**MSP ZONING ORDINANCE  
BOARD OF ADJUSTMENT MEETING**

SUBJECT: **Variance Request for MnDOT's I-494/TH 77 Dry Ponds in Bloomington, MN**

In the Matter of the Application/Petition for  
Variance of Runway 4 Zone B Restrictions for  
the MnDOT Dry Ponds at the I-494 / TH 77 Intersection

### **Findings, Conclusions and Approval of Variance with Conditions**

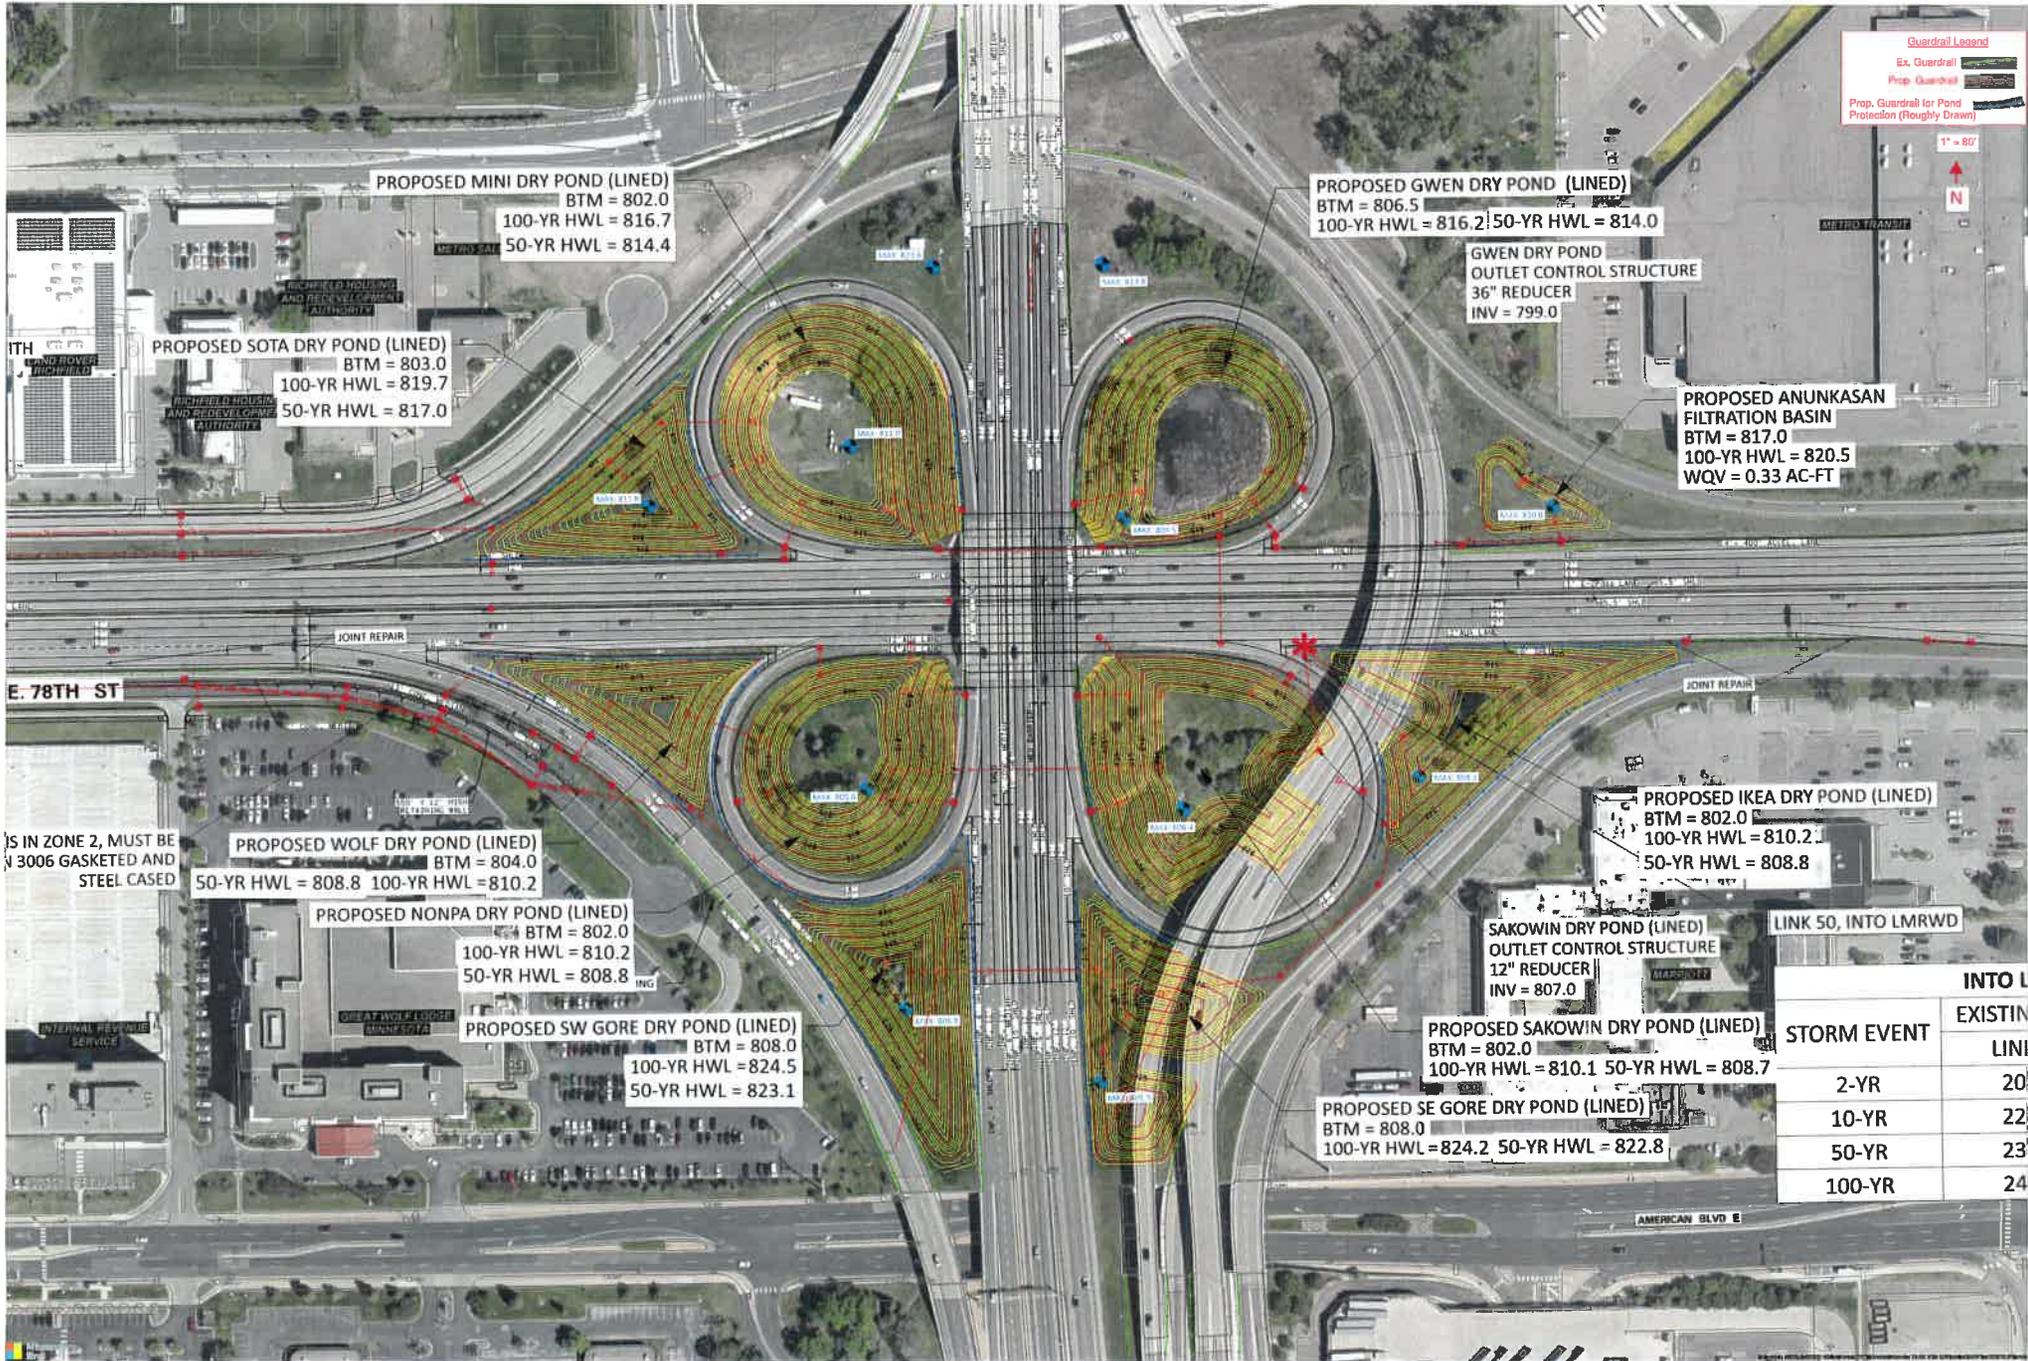
After reviewing the provided memo regarding the proposed dry basins located at the 494/77 interchange, USDA Wildlife Services does NOT believe the proposed will increase wildlife hazards at MSP airport. If designed following the MSP Zoning Ordinance incorporating dry basins, liners for groundwater prevention, and outlets to drawdown within the 48hr FAA recommendation, WS Does not see them as an attractant for waterfowl. Further, the “draft criteria” for incorporation into contract documents, seem sufficient to monitor future performance of the ponds post-project.

Thanks for taking my call today regarding review of the proposed design being considered for MnDOT's I-494 Project 2 Improvements near the Minneapolis-St Paul Airport. I've attached a brief memo that we had originally prepared for MAC describing the proposed dry basins that are proposed at the 494/77 interchange. Also attached is a zoomed in figure with the proposed grading of these basins.
